Recommendations from Imtac on public realm proposals for the Clifton Gateway in Belfast

(November 2018)

This report has been developed by Imtac in response to a request from the Department for Communities (DfC) for a street audit of the area covered by the proposed Clifton Gateway Project in Belfast. Following an audit undertaken in September 2018 this paper examines current issues and challenges on the streets concerned as well as setting out the key recommendations of the Committee designed to ensure planned improvements deliver maximum benefits for older people and disabled people in particular.

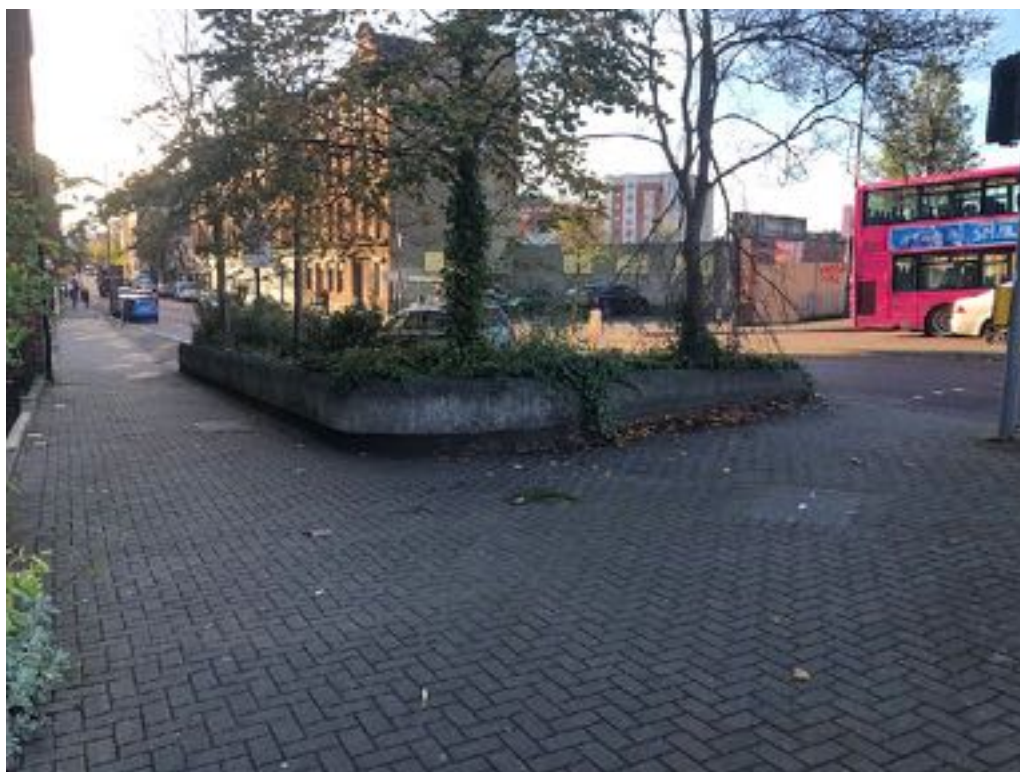
There is a staggered pedestrian crossing with central traffic island across Donegall Street at its junction with Carrick Hill. An uncontrolled rather than a controlled crossing provides access from the western footway to a traffic island. This is likely to create difficulties for some people with a visual impairment. The depth of tactile paving and location of control boxes are issues.

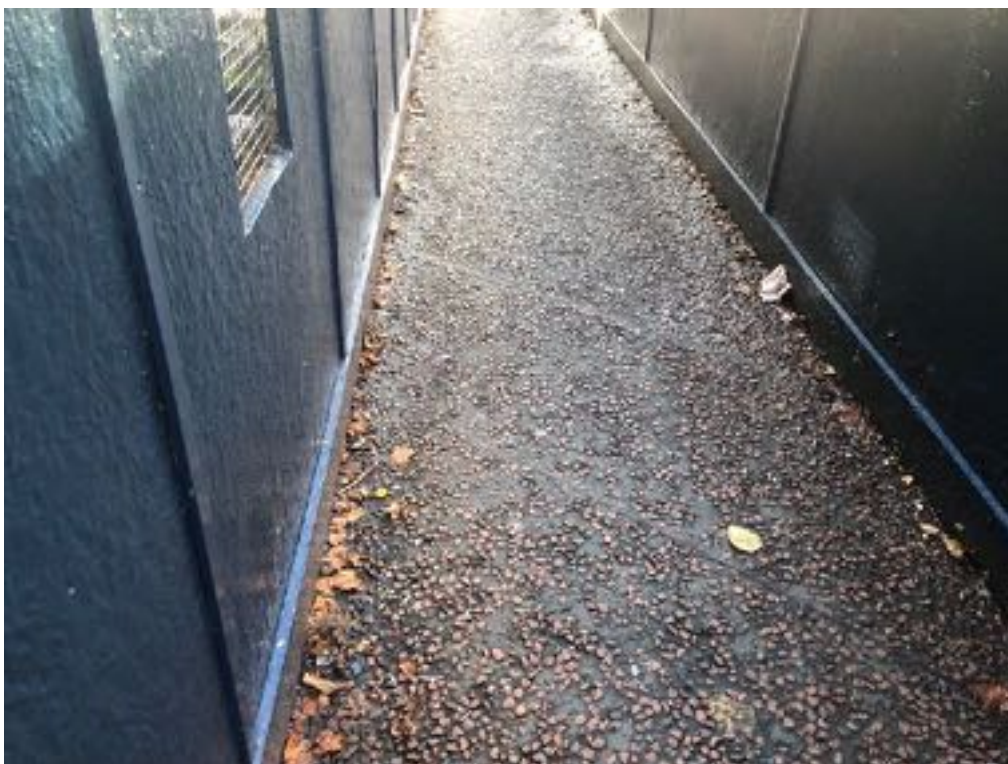
The eastern footway narrows considerably outside the Irish News offices. Railings create further narrowing as the footway turns sharply round the corner of the building.

The footway after this turn is relatively clutter free with signage and trees located in a line close to the kerb.

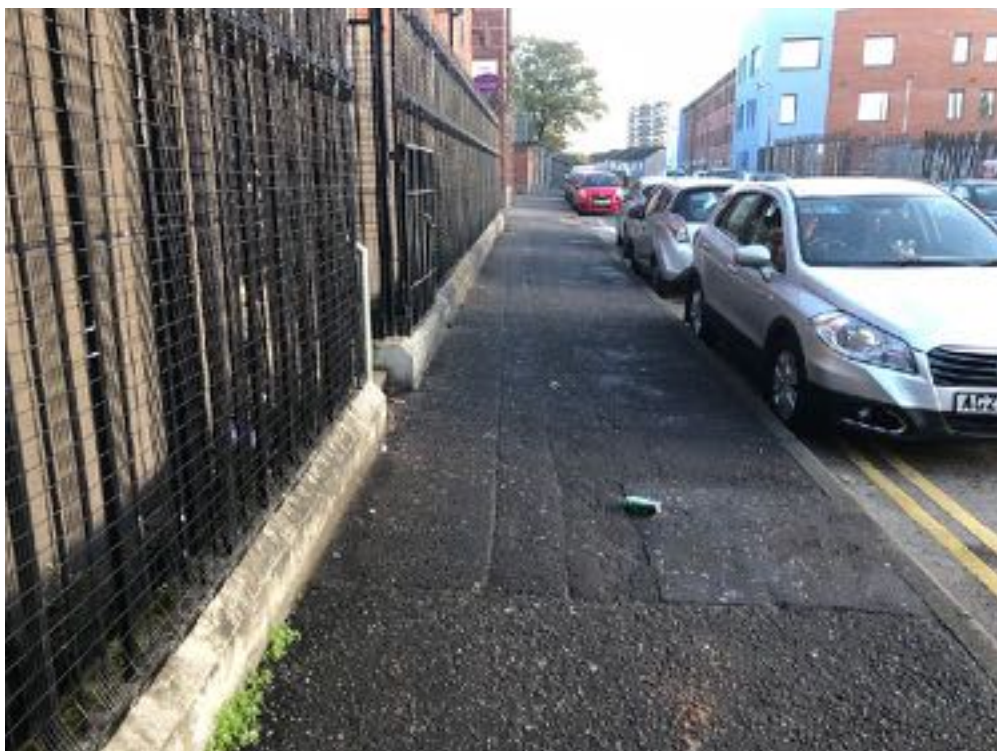
A kerbed vehicle entrance to an off-street car park means step free access along the southern footway of Stanhope Street is impossible.

The condition of the northern section of footway is very poor and parked cars reduce its width.

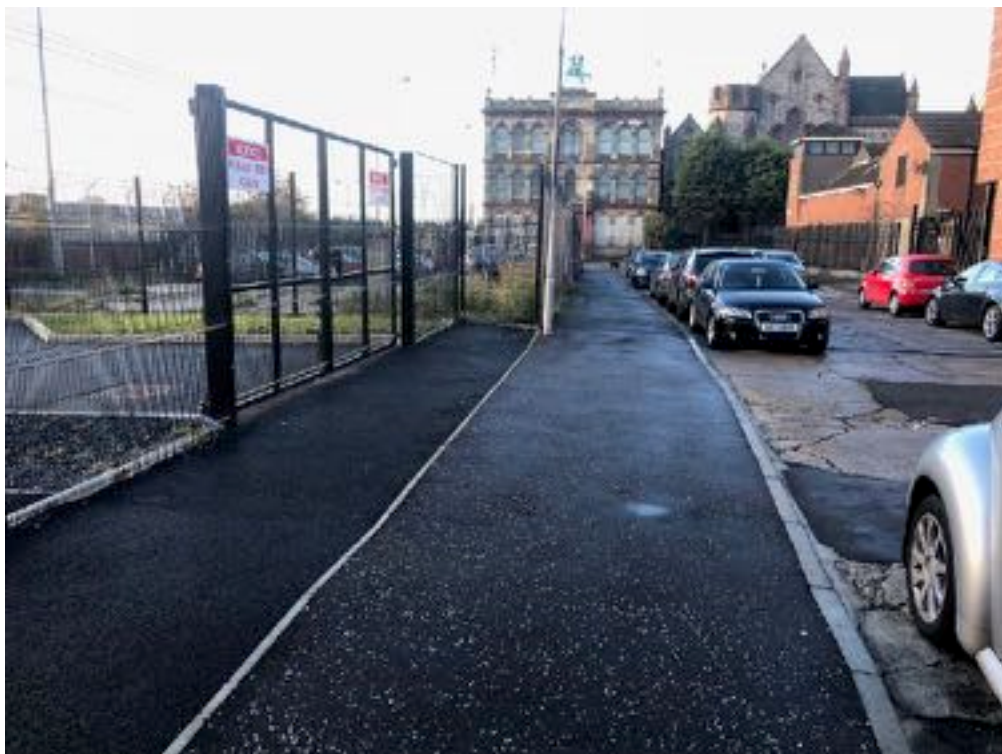
The granite kerbs around the entrance to the historic Clifton Street Cemetery mean there is not barrier free access to the cemetery or the footway as it continues eastwards.

The southern section of footway is clutter free and is in much better condition. However there is a lengthy section of footway flush with the carriageway which could potentially allow someone with a visual impairment to stray onto the carriageway.

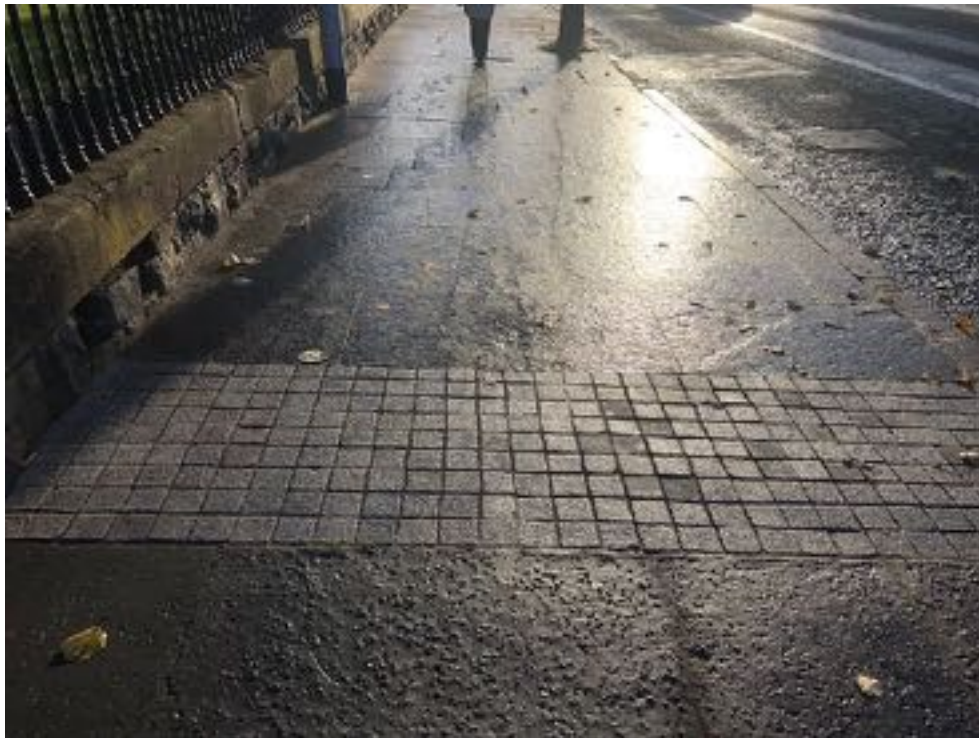
A-Boards associated with the garage obstruct the footway which is rough and uneven.

The kerbs are dropped at the garage exit but there is no tactile paving provided to warn pedestrians with a visual impairment. A Boards again obstruct the footway after the exit.
